Subject: FW: lighting level assessment for pedestrian crossing - quote
Date: Friday, 5 June 2020 at 6:04:53 pm Australian Eastern Standard Time
From: Jenny Watt
Attachments: image001.jpg, image002.jpg, image003.jpg, image004.jpg

From: Cheralee Heynes <cheralee@jdg.com.au>
Date: Sunday, 19 April 2020 at 6:31 pm
To: Jenny Watt <jenny@mandlinvestments.com.sg>
Cc: Michael Babbage <Michael.Babbage@ttw.com.au>, "Stephen. Brain" <Stephen.Brain@ttw.com.au>
Subject: RE: lighting level assessment for pedestrian crossing - quote

The below are three photos taken. The first at day, second at night facing north toward the crossing and the third at night facing south away from the crossing.

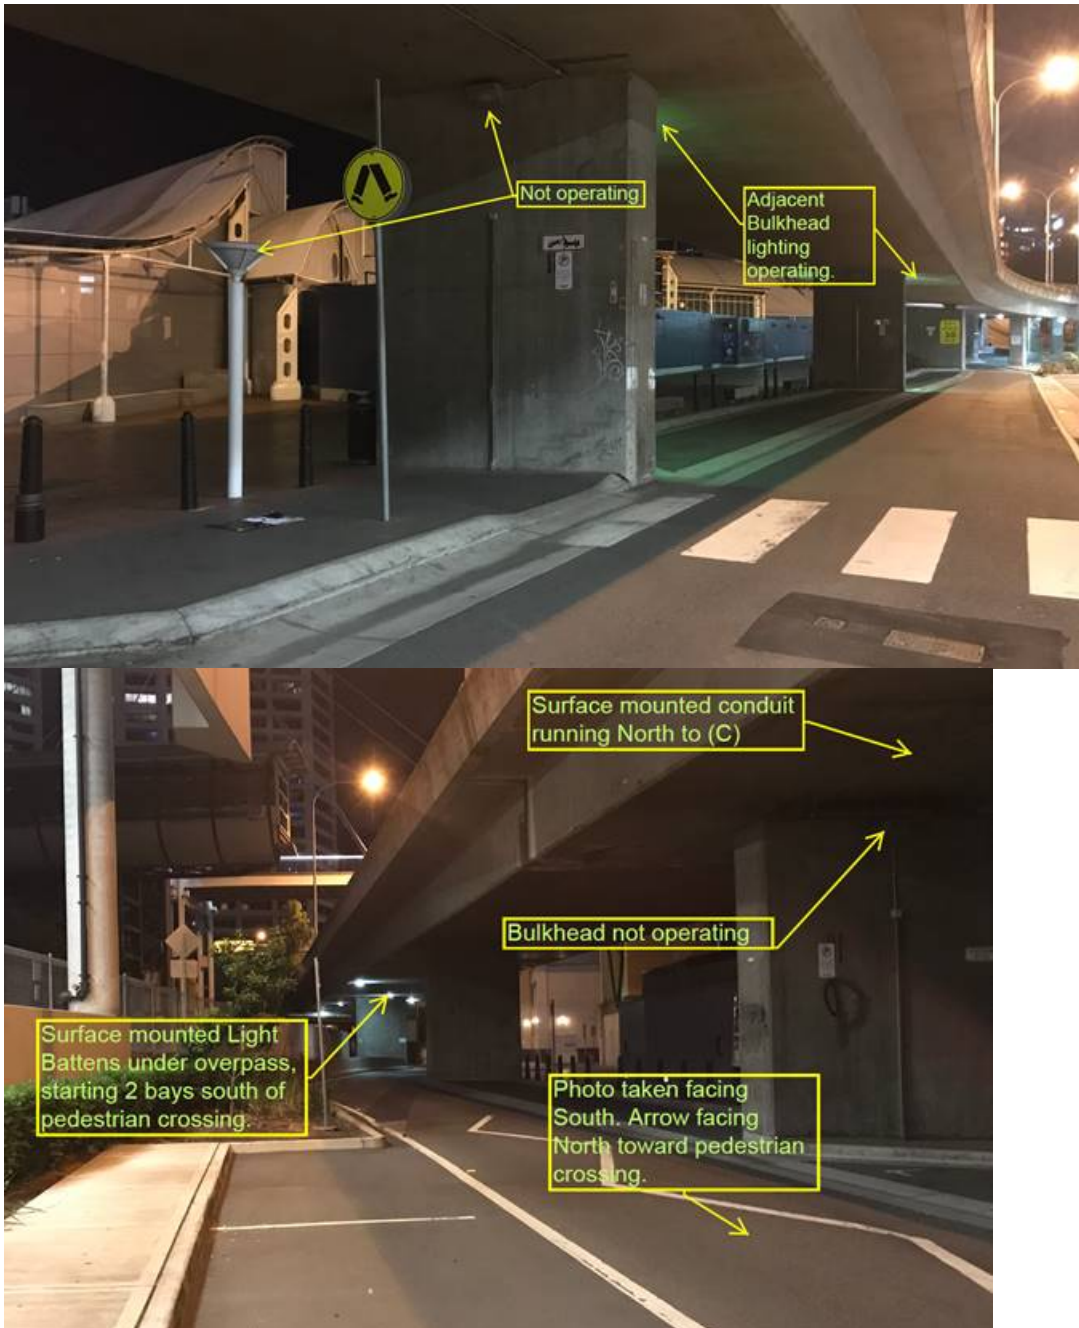
- The vertical illumination levels measured at all compliance points on the crossing ranged between 5.9 Lux (D) and 15.1 Lux (F). These values are lower than the minimum pedestrian crossing lighting levels of 32 Lux required.

- Adjacent Bulkhead (A) and Post Top (B) lighting are currently not operating. All lighting to the pedestrian crossing is currently from light spill.
- Bulkhead lighting in the adjacent northern bays are operating. In the locations shown above, vertical illumination levels measured at the adjacent bay were approximately 6 Lux and a maximum of 29 Lux was measured in the next northern bay. These measurements were taken at locations on the Western side of the road in line with (D). Illumination levels dropped away toward the opposing kerb in line with (F). These two bulkheads have different lamp sources and there is potential for an alternative lamp source to provide illumination above 32 Lux however this minimum level is unlikely to be achievable across all 18 compliance points of the crossing using the existing fitting type.

- An operating Post Top such as (B) luminaire was not found and could not be measured. The Post Top style is also not an appropriate light fitting to provide sufficient vertical illumination to a pedestrian crossing.

- The location of the existing bulkhead (A) is not positioned to provide incident light on the crossing from the direction of the oncoming traffic (the plain used to measure the vertical illumination for compliance)
- It is concluded the existing luminaires, if operational, or upgrade of these luminaires, will not provide the required illumination levels to achieve compliance.

- Install a directional flood light at (C), directed to the centre of the pedestrian crossing (E) and connect into an existing local lighting circuit.
- This arrangement needs the following confirmation:
 - Capacity to connect an additional 1 Amp into a local circuit. NB: This is unlikely to be an issue.
 - The local circuit is controlled by Photo electric (PE) Cell. This ensures the lighting will operate at all times in the absence of daylight such as the expected arrangement for the light battens under the overpass to the south.
 - Ownership of the lighting circuits. NB: It is expected the existing lighting circuits will be owned and operated by Transport NSW (RMS) due to the location and intended function.
